Re: San Jacinto River Waste Pits Superfund Site U.S. Army Corps of Engineers Feasibility Study Review

This letter provides comments on the *Evaluation of the San Jacinto Waste Pits Feasibility Study Remediation Alternatives* (U.S. Army Corps of Engineers (USACE) August 2015) (USACE Report). It is submitted on behalf of the Respondents, International Paper Company (IP) and McGinnes Industrial Maintenance Corporation (MIMC), named in the Unilateral Administrative Order (UAO) for the Remedial Investigation/Feasibility Study (RI/FS) at the San Jacinto River Waste Pits Superfund Site (Site) in Channelview, Texas (U.S. Environmental Protection Agency Region 6 (USEPA), CERCLA Docket No. 06-03-10 UAO for RI/FS).

## ARMORED CAP WATER EDGE DETAIL

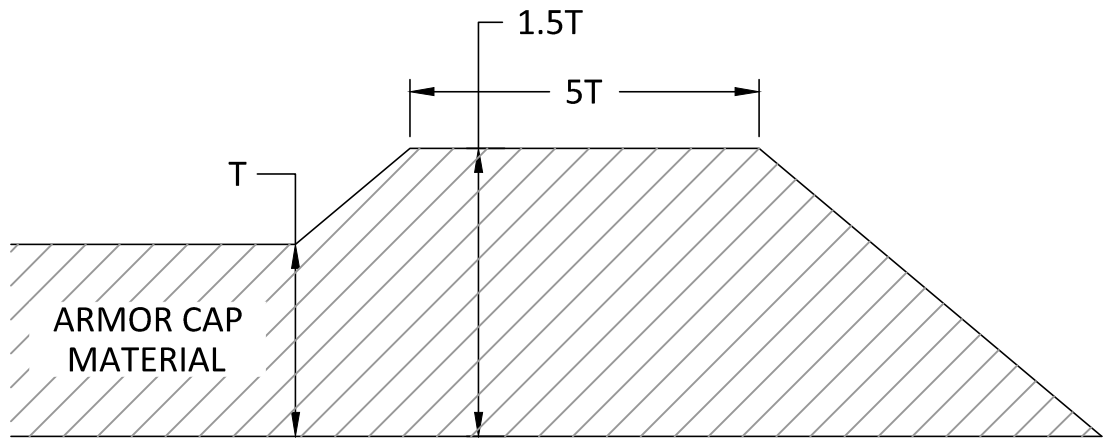
- The USACE Report also evaluates the potential impact of toe erosion and cap undermining, and the potential impact of storm surges. The current armored cap includes a thickened edge that is designed to minimize the potential risk of toe erosion and cap undermining. Enhancements to the thickened edge are included in
-

Alternative 3N (Figure 1). The recommendations presented by the USACE would further improve the performance of the edge. In regards to the potential impacts of storm surges, it should be noted the TCRA armored cap was designed to resist the worst case erosion resulting from a range of storm conditions, and was evaluated to demonstrate that the cap armor will not erode during storms up to and including a 500-year recurrence interval event.
